# Staff Summary Report

**SUBJECT:** Hold a public meeting for a Development Plan Review for CHILDSPLAY located at 900 South Mitchell Drive.

**COMMENTS:** Request for **CHILDSPLAY (PL070079)** (Childsplay, property owner; Peter Fischer, DPA Architects, applicant) for the removal of an existing building and addition of a new +/-29 feet high, +/-7,466 s.f. building and new parking stalls on 2.87 acres, located at 900 South Mitchell Drive, in the R1-6, Single-Family Residential District, including the following:

**DPR07085** – Development Plan Review including site plan, building elevations and landscape plan.

**PROPOSED SITE PLAN**  
 SCALE: 1" = 30'-0"

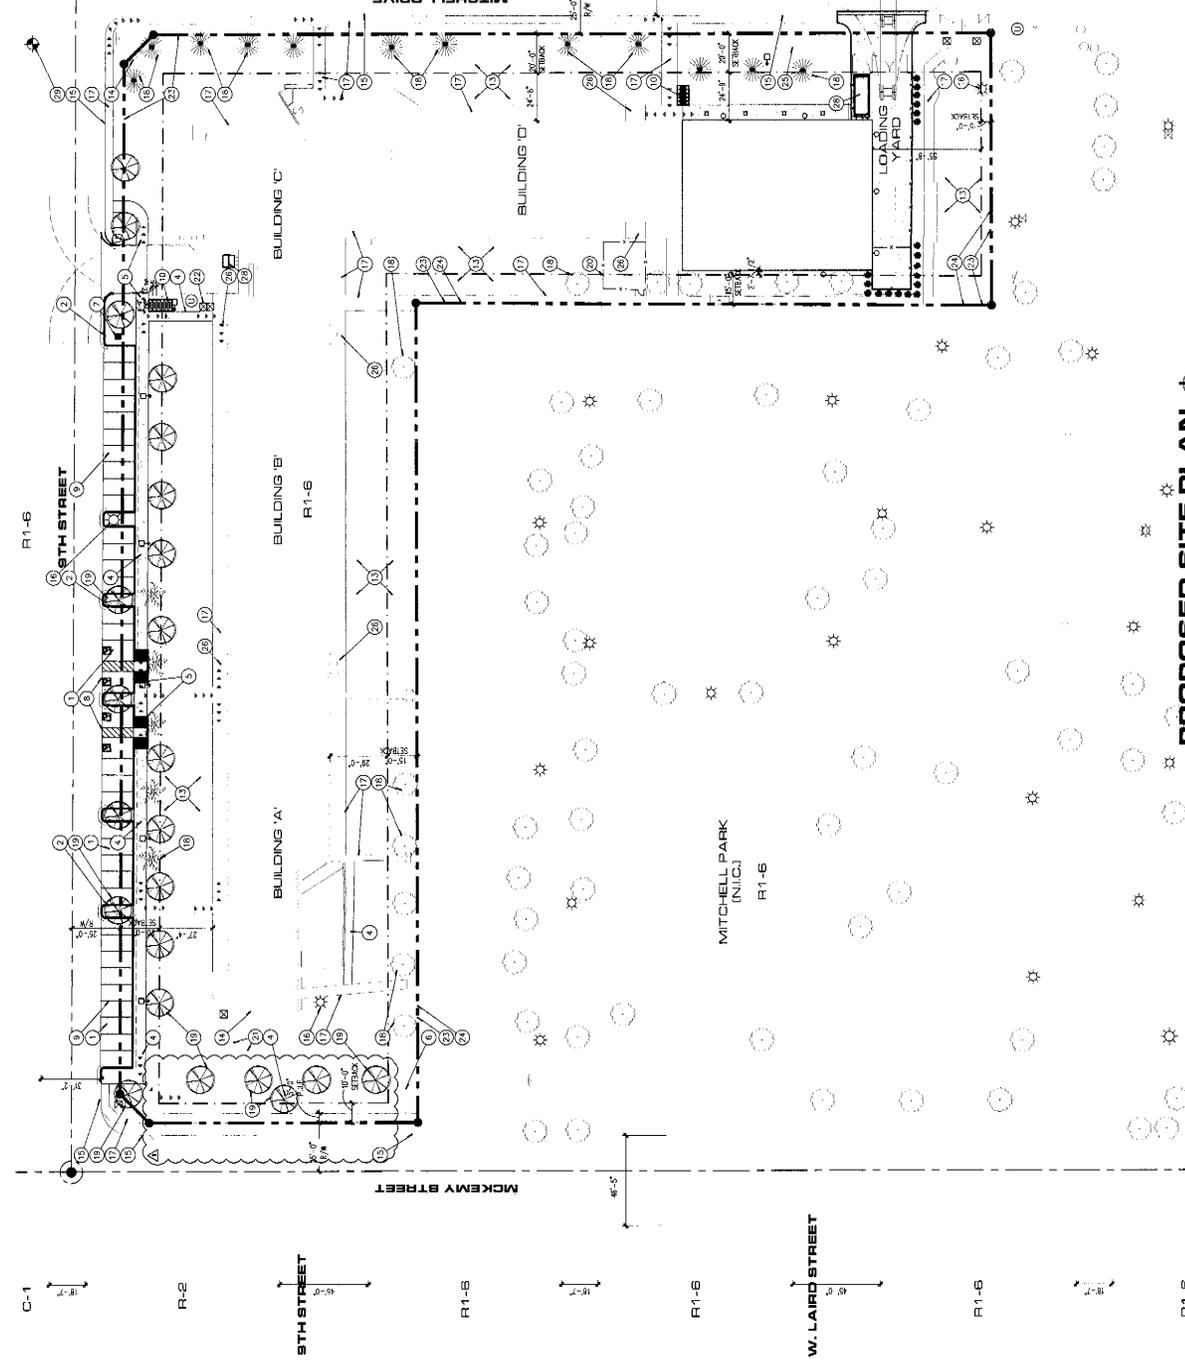
2. Provide 6'-0" wide public sidewalks along streets where sidewalk is relocated, or as required by Traffic Engineering Design Criteria and Standard Details.
3. If rolled curb is removed, replace with vertical curb and gutter.
4. Dedicate a public access easement along the portion of sidewalk located outside of the existing rights of way.
5. Provide 8'-0" steel vertical picket fence with wood slats for enclosed service yards, or similar construction. Provide gates of height that match that of the adjacent enclosure walls.
6. Place exterior, freestanding reduced pressure and double check backflow assemblies in pre-manufactured, pre-finished, lockable cages (one assembly per cage). If backflow prevention or similar device is for a 3" or greater water line, delete cage and provide a masonry or concrete screen wall

- Driveways:
  - Correctly indicate clear vision triangles at both driveways on the site and landscape plans. Identify speed limits for adjacent streets at the site frontages. Begin sight triangle in driveways at point 15'-0" in back of face of curb. Consult "Corner Sight Distance" leaflet, available from Development Services Counter or from John Brusky in Transportation (480-350-8219) if needed. Do not locate site furnishings, screen walls or other visual obstructions over 2'-0" tall (except canopy trees are allowed) within each clear vision triangle.

- Parking spaces:
  - Verify conformance of accessible vehicle parking to the Americans with Disabilities Act of 1990 (42 U.S.C.A. §12101 ET SEQ.) and the Code of Federal Regulations Implementing the Act (28 C.F.R., Part 36, Appendix A, Sections 4.1 and 4.6). Refer to Standard Detail T-360 for parking layout and accessible parking signs.

- At parking areas, provide demarcated accessible aisle for disabled parking.
  - Distribute bike parking areas nearest to main entrance(s). Provide parking loop/rack per standard detail T-578. Provide 2'-0" by 6'-0" individual bicycle parking spaces. One loop may be used to separate two bike parking spaces. Provide clearance between bike spaces and adjacent walkway to allow bike maneuvering in and out of space without interfering with pedestrians, landscape materials or vehicles nearby.

**BUILDING 'E' EAST ELEVATION 1**  
SCALE: 1/8" = 1'-0"

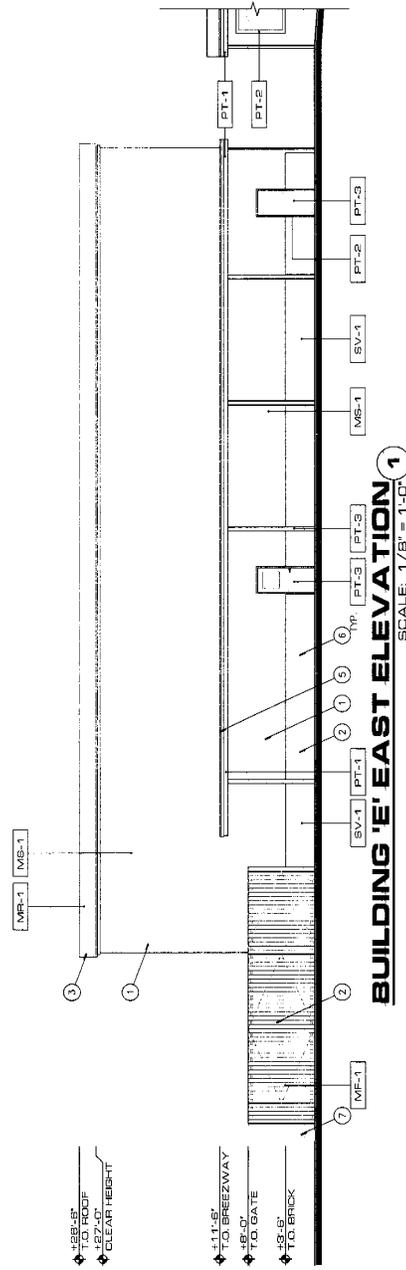
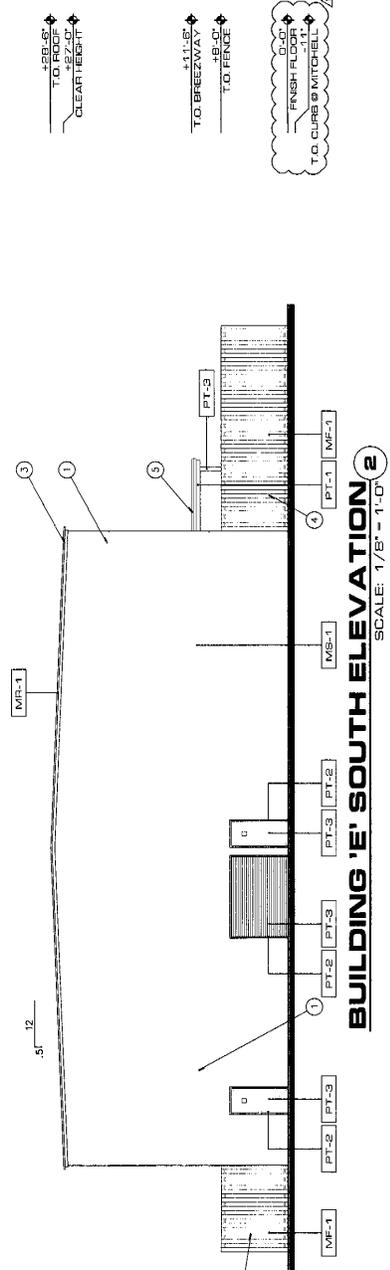
8. The new building addition shall provide on all elevations brick veneer, matching the height and style of existing building facades.
9. Future proposed "artist mural" on the west elevation of the building not authorized with this request. Separate review and consideration required with the Development Review Commission.

10. The applicant shall make reasonable efforts to reduce any potential noise within the new building, such as providing sound dampening walls.
11. Provide main colors and materials with a light reflectance value of 75 percent or less. Specific colors and materials exhibited on the materials sample board are approved by planning staff. Submit any additions or modifications for review during building plan check process. Planning inspection staff will field verify colors and materials during the construction phase.

Building E – is an eyesore.  
Would like it to blend better with the rest of the buildings.  
Would like it to be moved to the North west corner on 9<sup>th</sup> street.  
- Connie Ferrell

I'd like to see large trees planted on the south side of the scene shop to soften the south elevation. The metal building is the least attractive portion of the project and would be more palatable with large trees. Thanks.
